ADVISORY COMMITTEE ON REACTOR SAFEGUARDS
UNITED STATES ATOMIC ENERGY COMMISSION
WASHINGTON, D.C. 20545

To : ACRS Members
From : Harold Etherington, ^{H.E.} ACRS Member
Subject: OYSTER CREEK, - PRESSURE VESSEL STUB TUBE FAILURES

FIG 1 CRD HOUSING : RADIAL CONTRACTION

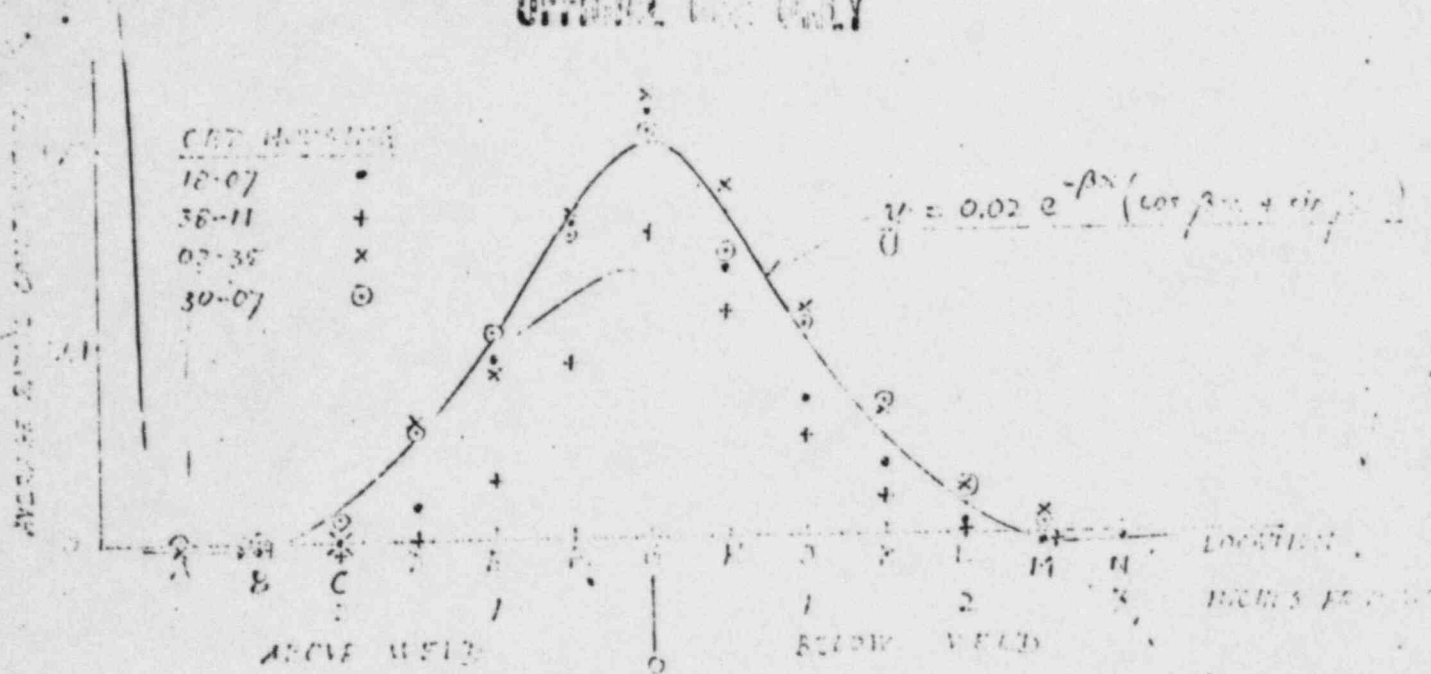
Radially Symmetric Distortion. It can be shown that the effect of bending moment exerted by the weld is small in comparison with the effect of direct radial force. The radial contraction is calculated as a function of distance from the weld and the results are plotted in Figure 1. The figure shows that the measured average radial deflection profiles for the Niagara-Mohawk housings conform to the shape of the profile calculated by elastic theory (wave length 6.14 in.). The maximum radial contraction (0.020 in.) in the calculated curve was selected empirically to match the measured maximum for CRDH's 18-07, 02-35, and 30-07. The measurements for CRDH 38-11 show somewhat less distortion but the shape of the profile is the same. The symmetry of measured data above and below the weld confirm the absence of any large bending moment induced by the weld.

FIG 2 CRD HOUSING : CALCULATED STRESS

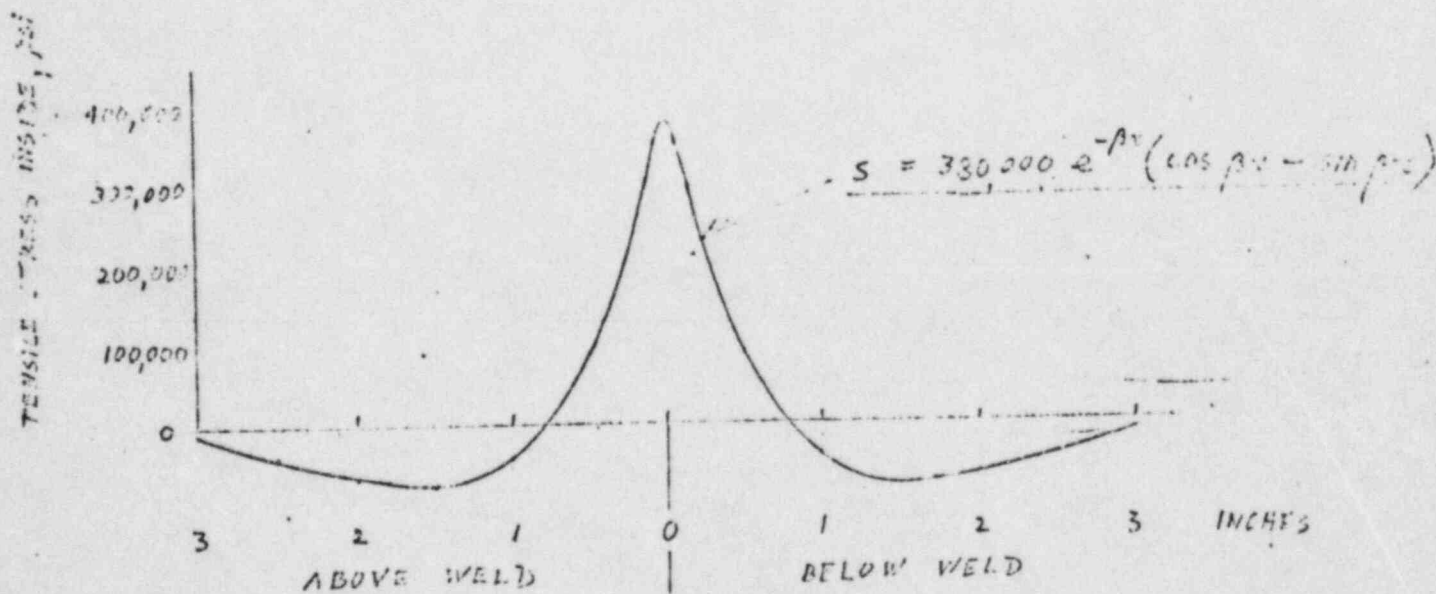
Figure 2 shows the peak stress, calculated by elastic theory for a modulus of elasticity of 28×10^6 psi, to be 380,000 psi. The figure shows the rapid decay of stress typical of this type of structure.

FIG 3 CRD HOUSING : RADIAL CONTRACTION
OYSTER CREEK

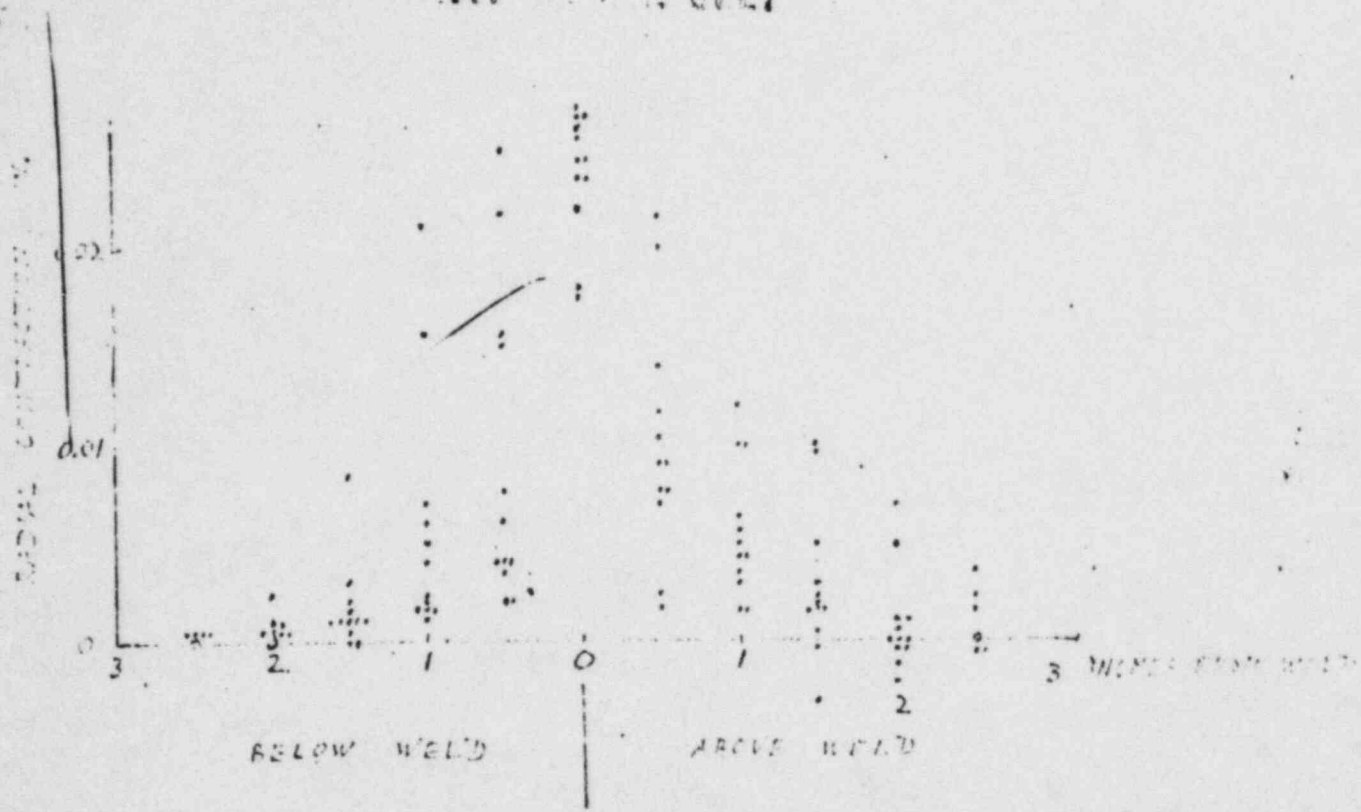
Figure 3 shows the data for the twelve outer-circle assemblies reported for the Oyster Creek vessel. The data appear to show a greater scatter than those for Niagara Mohawk and a tendency to more abrupt decay with distance from the weld. Factors that could lead to the condition include possibly poorer quality control of field welding procedures, an out-of-round condition (measurements were made on a single diameter), or possibly inferior quality of the data.

FIG 4 CRD HOUSING : (CT-37-FOUN)

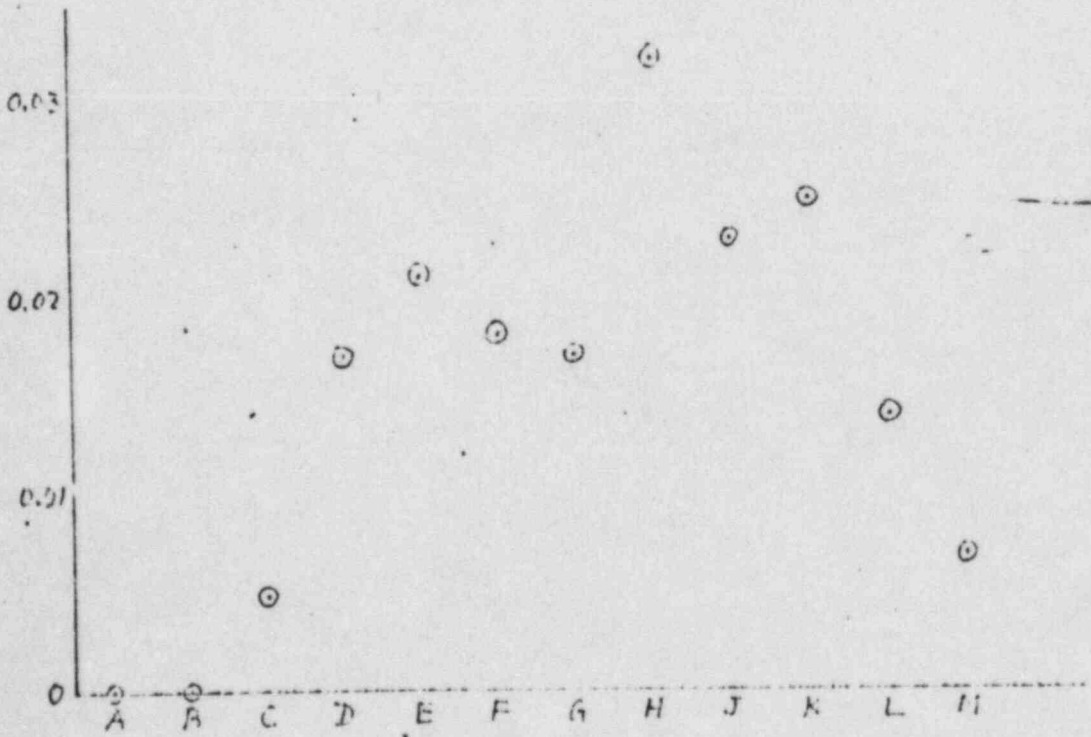
Calculations (not attached) show that the force required to produce the measured deflection is an order of magnitude less than the total distributed radial force and that the stress is still smaller. The differences in diameter for housing 30-07, which showed the greatest out-of-round, are plotted in Figure 4.

FIG. 5. STUB TUBE: RADIAL CONTRACTION
 NIAGARA NONAWT.

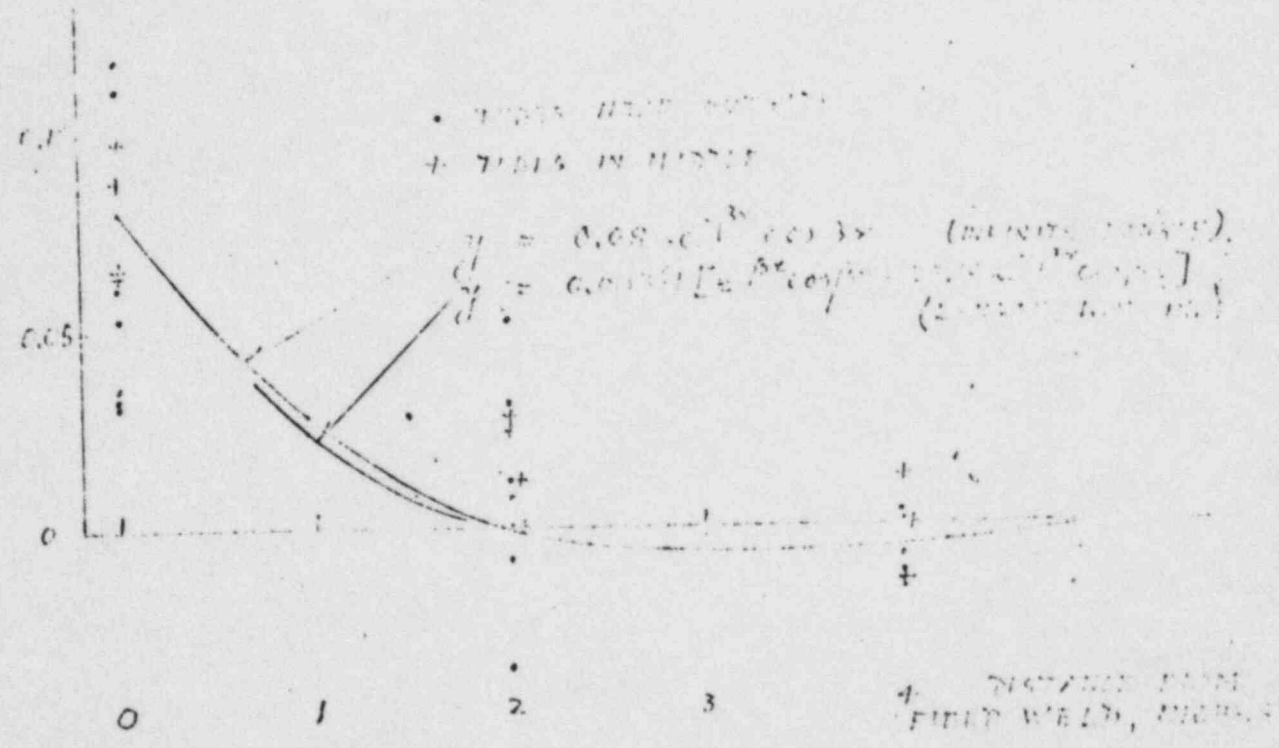
Bending. The continuous curve in Figure 5 shows the calculated radial contraction as a function of distance for a tube of infinite length, and part of a similar curve for a tube 1.95 in. long, both for a maximum radial displacement of 0.08 in. at the field weld. Displacement curves have also been calculated but not plotted for lengths of 2.92 in., 3.89 in., and 4.86 in. In all cases, as suggested by Figure 5, the curves lie close to the curve for infinite length, except that departure occurs as necessary to meet the condition of zero displacement at the terminal point corresponding to the fixed (shop weld) end of the stub tube. In summary, for a given displacement at the weld, the calculated deflection curve is only slightly dependent on length for stub tubes two inches long or more. For still shorter tubes, more radical departure is necessary to meet the end condition.

As reported for the CRDH Niagara-Mohawk data, the stub tube measurements in Figure 5 show a wide scatter, but are not inconsistent with the calculated conclusions. Measurements for tubes well within the array are plotted with crosses, and, as would be predicted from the analysis, these fall within the pattern of data for tubes near the periphery.

FIG 1 ATTACHMENT C

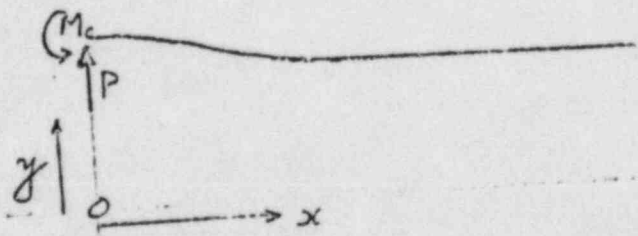
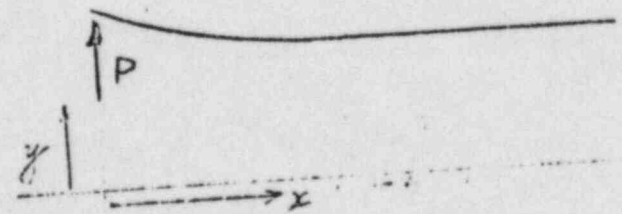
The shop-induced stress is caused by differential contraction of the austenitic steel stub tube and the pearlitic steel vessel (and Inconel weld) during cooling from the stress annealing operation. Suppose the vessel and stub tube are essentially stress free at the stress relieving temperature, i.e., omit the refinement of allowing for relatively small residual stresses in the base materials and the larger stresses probable in the Inconel weld. If the stub tube and vessel were free to contract independently, the outside radius of the stub tube would be 0.010 in. smaller than the corresponding opening in the vessel. The stub tube is therefore pulled out as shown in Figure 1 a.

1. The tube may be held rigidly as in Figure 1 b.
2. The weld may yield and relieve the bending moment as in Figure 1 c.

Case 1. Stress in Stub Tube with Rigid Constraint. For the case shown in Figure 1 b, constants of the general formula of Attachment A are $A = B = 0$ and $C = D = 0.01$.

Stress in Stub Tube with Free End. For the case shown in Figure 1 c, constants of the general formula are $A = P = D = 0$ and $C = 0.01$.
